TECHNICAL BULLETIN
TB-24-001

Title: Pole Guy Installation Standards Revision

Issue Date: 12/26/2024

Department: Distribution Standards and Materials

STANDARD NO. F-1-3 VERSION 6
DOCUMENT NO. 4301.087
PAGE 1 OF 2 DATE DEC 26, 2024
SUBMITTED LUIS R. SOTO LIC. 11658
REVIEWED IVETTE D. SANCHEZ LIC. 13837
APPROVED RICARDO CASTRO LIC. 12135
DIGITIZED EMILIO CUADRADO LIC. 3000
VICTOR R. FEBRES LIC. 3412

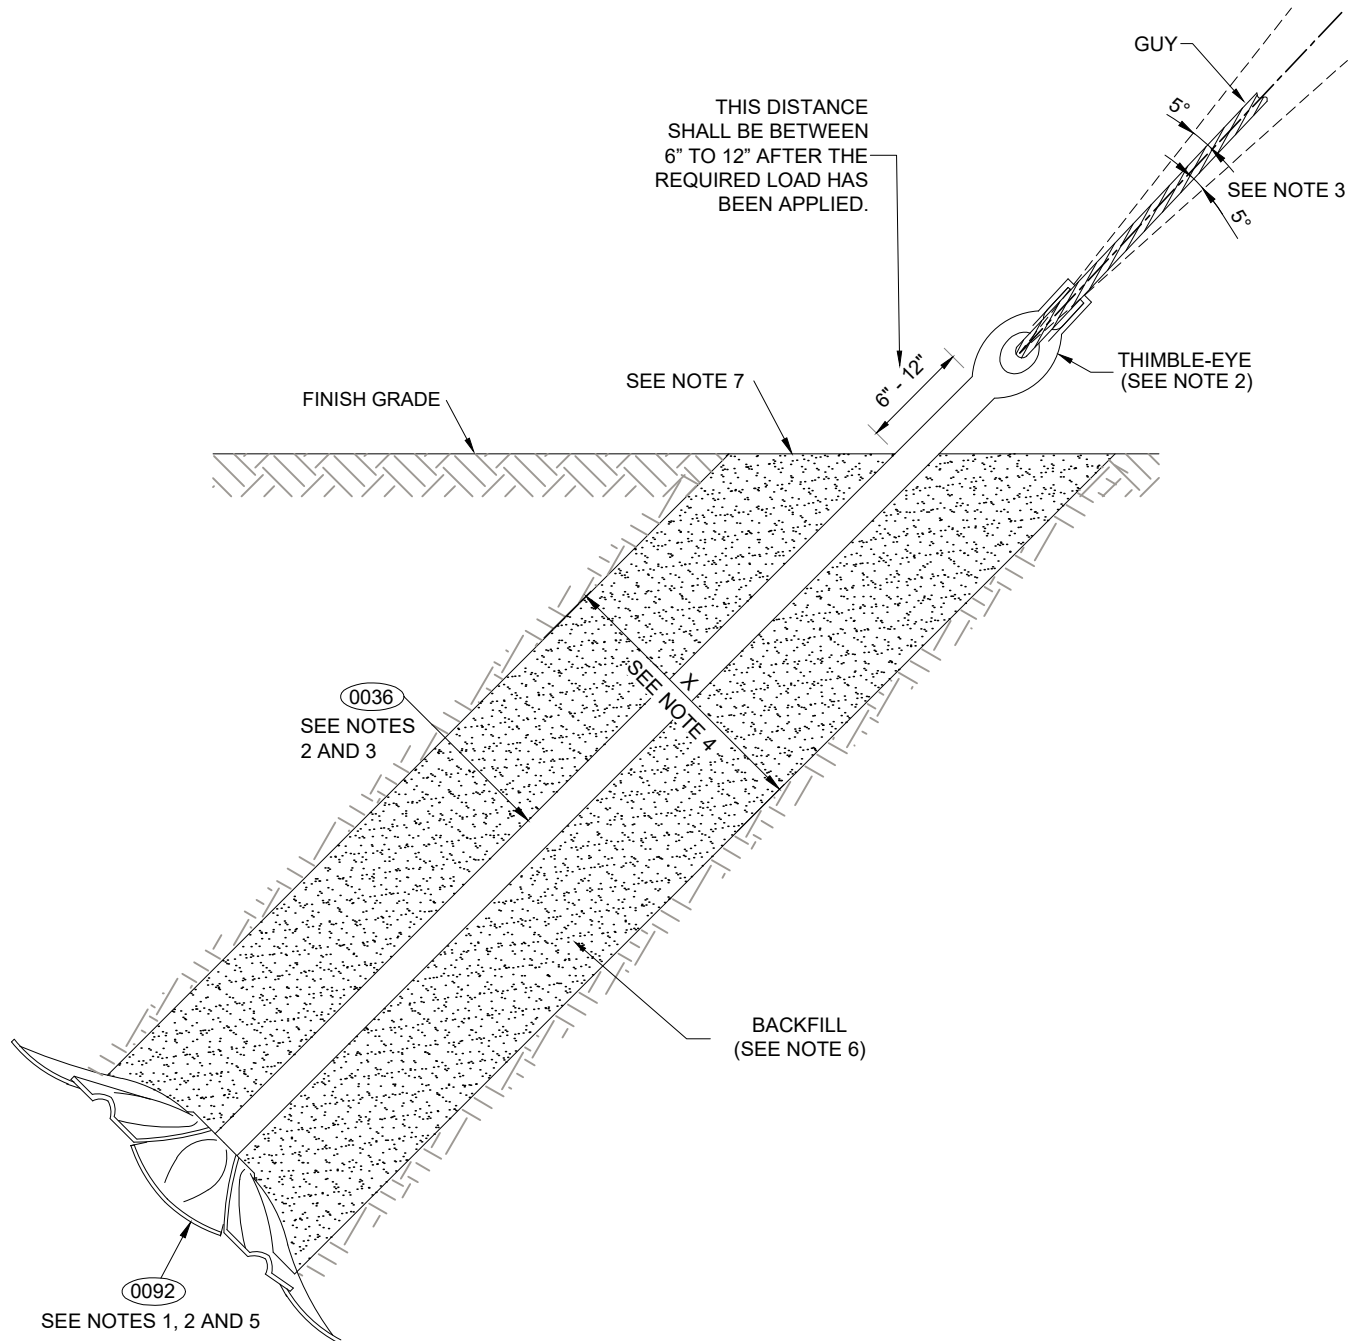
Version 5 of the Manual includes version 5 of standard no. F-1-3, Expansion Anchor, document no. 4301.087, dated January 18, 2024. The materials specified in this standard are the 12-inch expansion anchor and the 1-inch by 10-foot anchor rod, both of which were used on poles with primary, secondary, or both primary and secondary lines. This standard has been revised to version 6, which now specifies the exclusive use of the 12-inch expansion anchor and the 1-inch by 10-foot anchor rod for primary lines or for both primary and secondary lines. Additionally, it introduces the 8-inch expansion anchor and the 5/8-inch by 7-foot anchor rod for use on poles that support only secondary lines. Consequently, standard no. F-1-1, *Anclaje de Expansión*, included in the PREPA document *Manual de Normas de Distribución Urbana*, dated 1986, is being cancelled and substituted by the revised standard no. F-1-3.

2. FOR STANDARD NO. E-1-2-3, POLE GUY INSTALLATION FOR PRIMARY LINES, USE THE 8-WAY 12" EXPANDING ANCHOR AND A 1" x 10'-0" ANCHOR ROD. FOR STANDARD NO. E-1-2, POLE GUY INSTALLATION FOR SECONDARY LINES, USE THE 8-WAY 8" EXPANDING ANCHOR AND A 5/8" x 7'-0" ANCHOR ROD.
